Job Information		Technical Data Sheet
Job Name	Webster Univ Science Bldg	
Date	7/5/2016	
Submitted By	Thermal Mechanics, Inc.	
Software Version	04.60	
Quantity	1	
Unit Tag	CUH-102

EQUIPMENT SUBMITTAL – REVISION “2”

Job Name: **Webster University
Interdisciplinary Science Building**

Shop Drawing Submittal Review

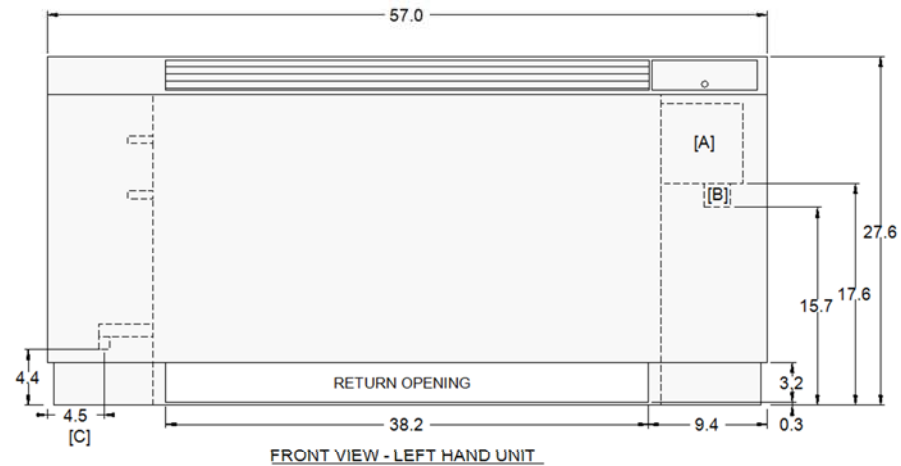
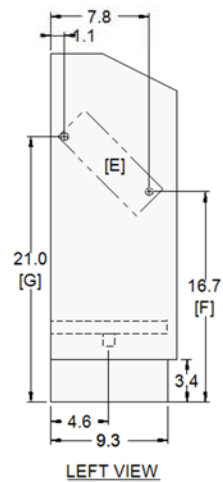
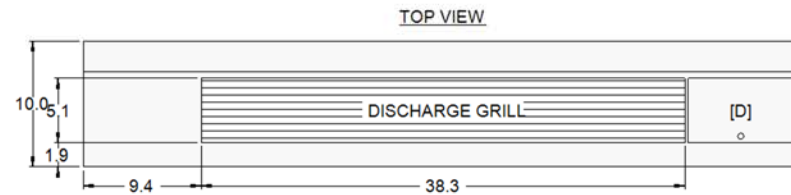
July 1, 2016 Comments	July 5, 2016 Response
1. Remove all control valves. Valves provided by control contactor.	Optional valve package and control valve has been removed from the cabinet heaters.
2. Is the disconnect factory mounted?	Yes
3. Remove all valve packages unless standard from the factory.	See above.
